**Re: GE-Pittsfield/Housatonic River Site  
Former Oxbow Areas A and C (GECD410)  
Addendum to Final Removal Design/Removal Action Work Plan**

GENERAL ELECTRIC COMPANY  
PITTSFIELD MASSACHUSETTS  
**FINAL RD/RA WORK PLAN ADDENDUM FOR  
FORMER OXBOW AREAS A AND C**

**PROPOSED DRAINAGE SWALE  
ACTIVITIES**

FIGURE  
**1**

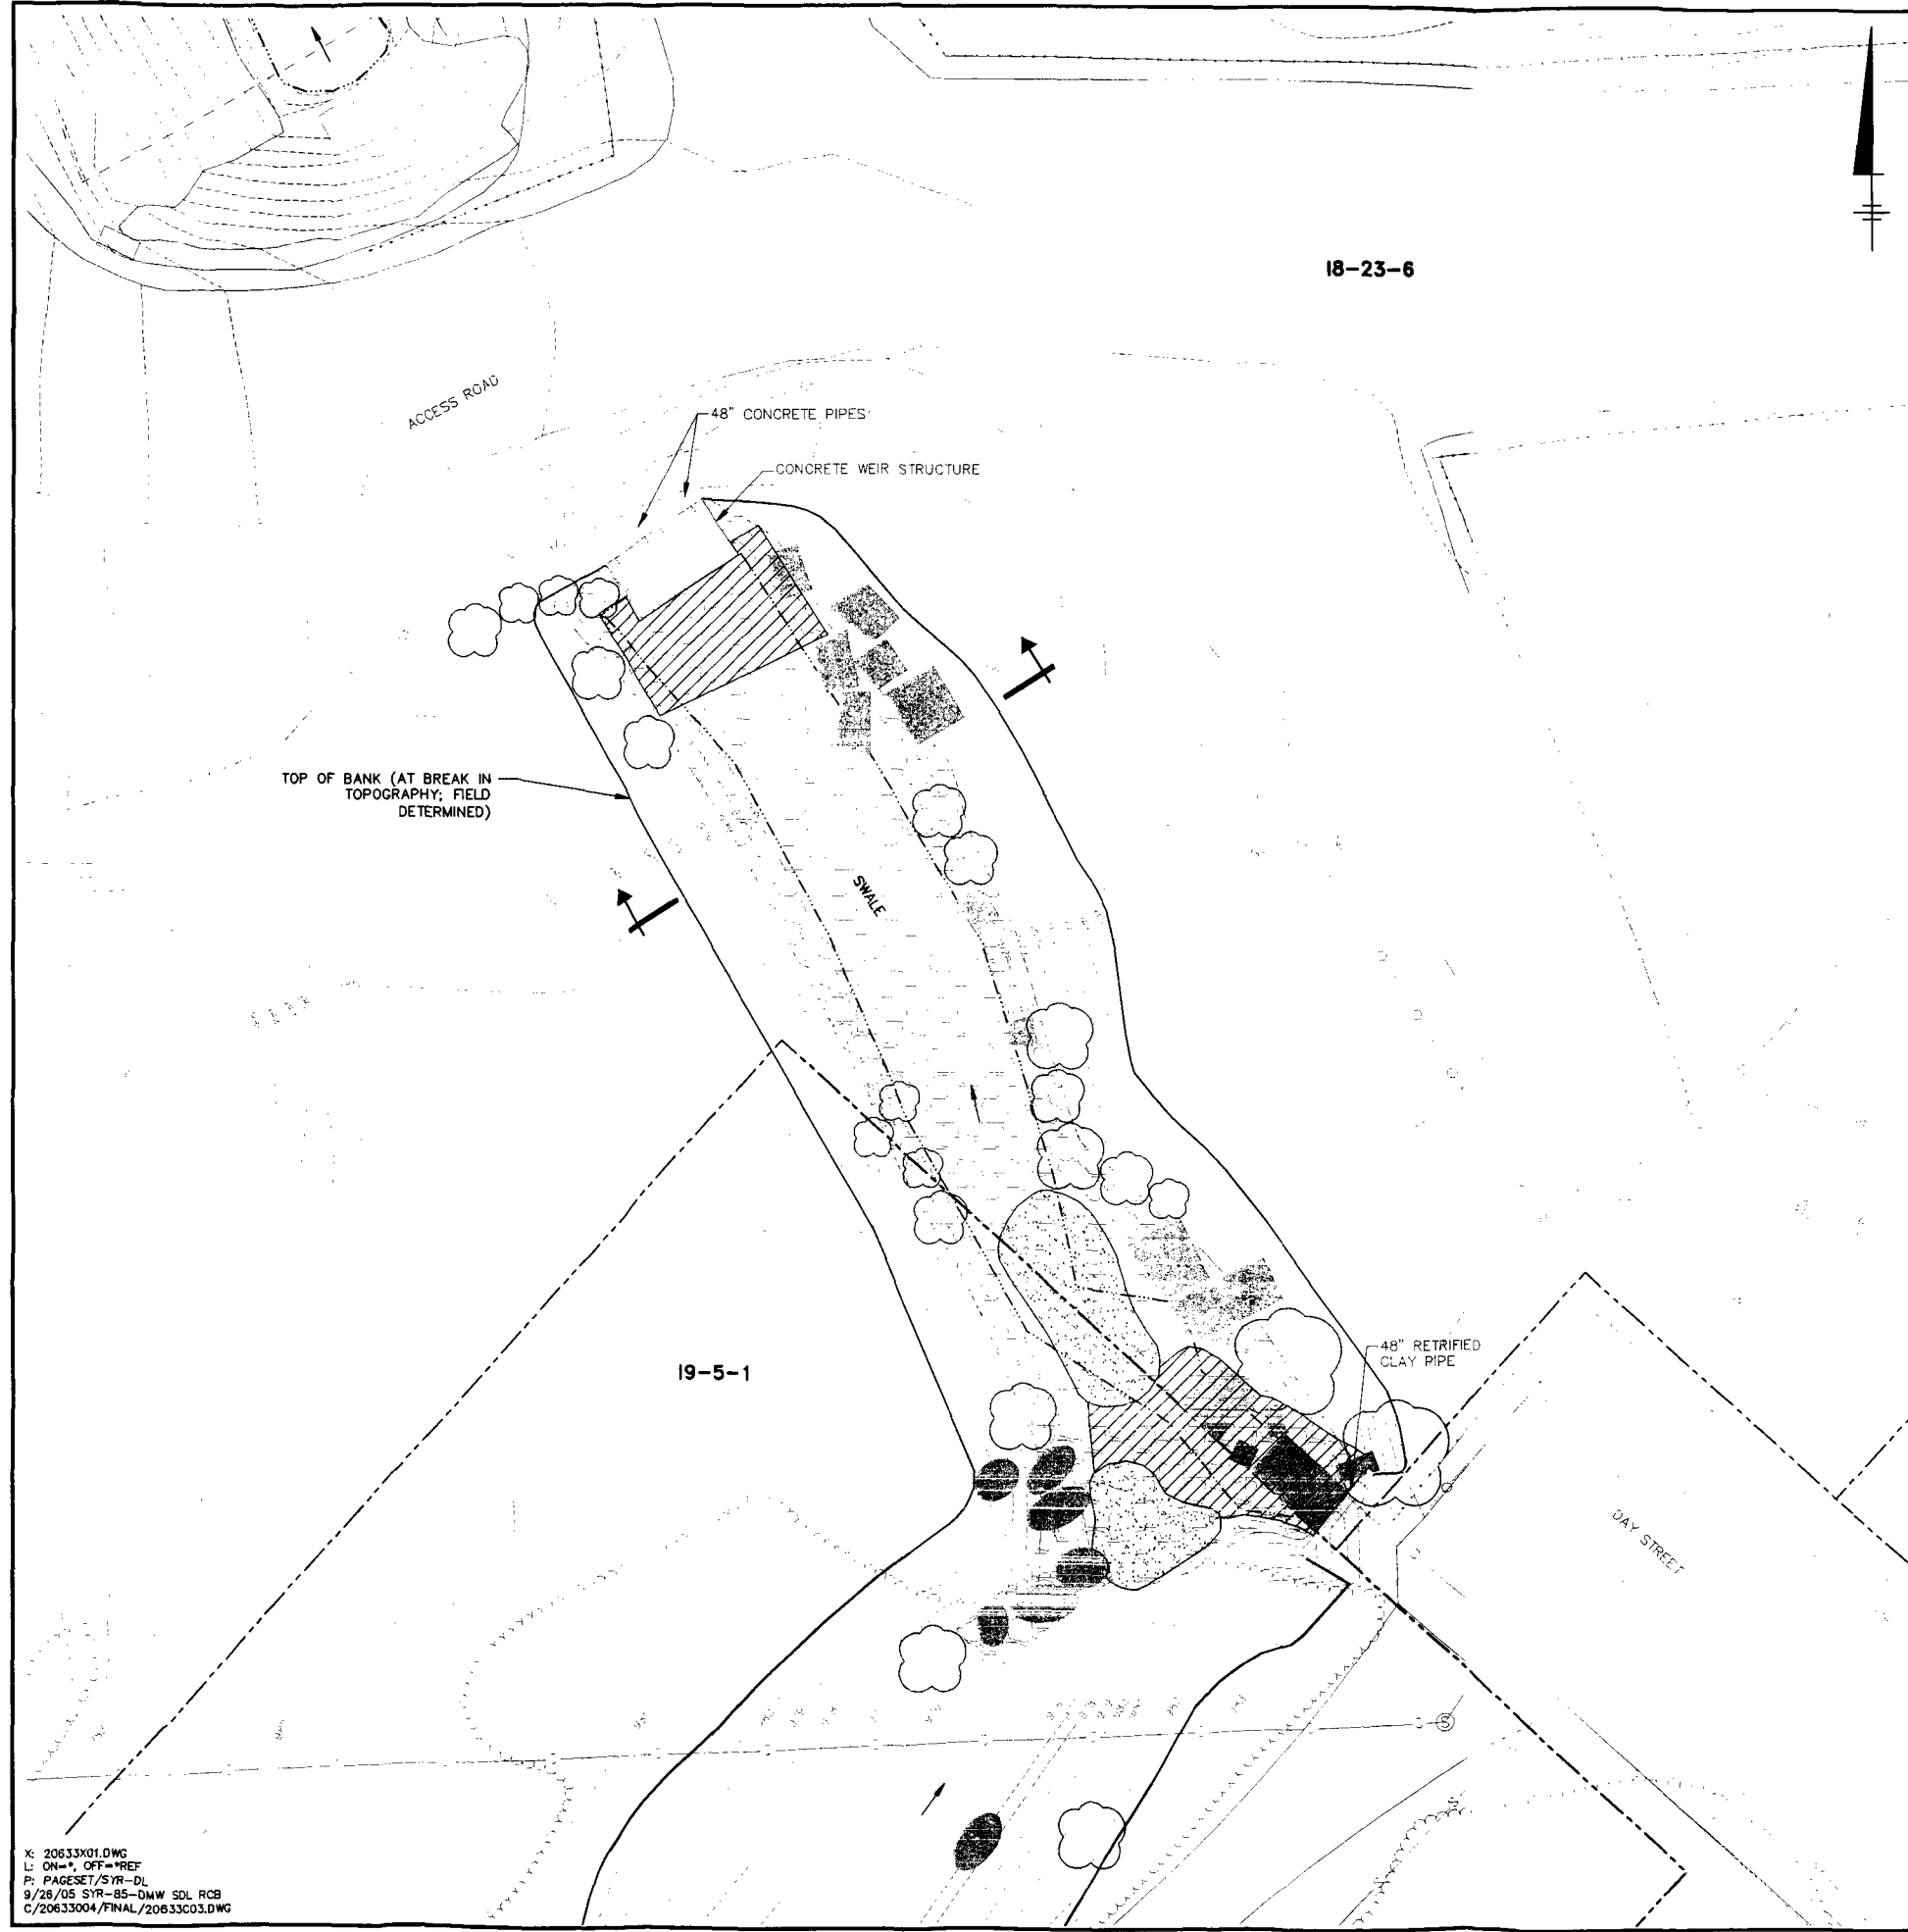
Prior to the placement of rip-rap, GE proposes to clear brush materials and remove accumulated debris (e.g., wood, bicycles, furniture, etc.) within and adjacent to the drainage swale. As shown on Figure 1, GE proposes to remove trees with a diameter less than 6 inches (at breast height) and boulders/concrete blocks less than 12 inches in their largest dimension, in the area of the swale to be covered with riprap. Trees and boulders/concrete blocks larger than those proposed for removal are also shown on Figure 1. Following the above-referenced removal activities, GE proposes to remove the accumulated sediment in the areas shown on Figure 1 to the approximate elevation of the bottom of the swale in the surrounding areas. In addition, GE proposes to place an approximately 12-inch thickness of rip-rap across the bottom and along the lower 2 feet of the banks of the drainage swale shown on Figure 1. Non-woven geotextile (10 oz.) will be placed below the riprap above the toe of bank and across the bottom of the swale. Specifications related to the size of riprap to be used are indicated on Figure 1. Sediment and soil within the bottom of the swale will be removed to a depth of approximately 1-foot prior to the placement of the riprap. In addition, riprap will be placed around larger trees and boulders/concrete blocks that are not subject to removal. Additional removal or regrading of soil will be performed at areas where existing

slopes will not otherwise allow for the stable placement of riprap. Based on the completed construction, GE will determine if there are any potential changes in flood storage capacity and propose to EPA to offset any such loss with compensatory flood storage.

As indicated in the Conceptual RD/RA Work Plan and Final RD/RA Work Plan, no soil removal is necessary within or adjacent to the drainage swale area to satisfy the applicable Performance Standards. However, as described above, sediment removal within the drainage swale and soil removal or regrading within its banks, will be conducted to accommodate construction activities. During sediment and soil removal activities, the selected Contractor will be responsible for providing the appropriate water diversion measures. The anticipated water diversion measures include an upstream diversion structure, bypass pumps and piping, and dewatering of the drainage swale.
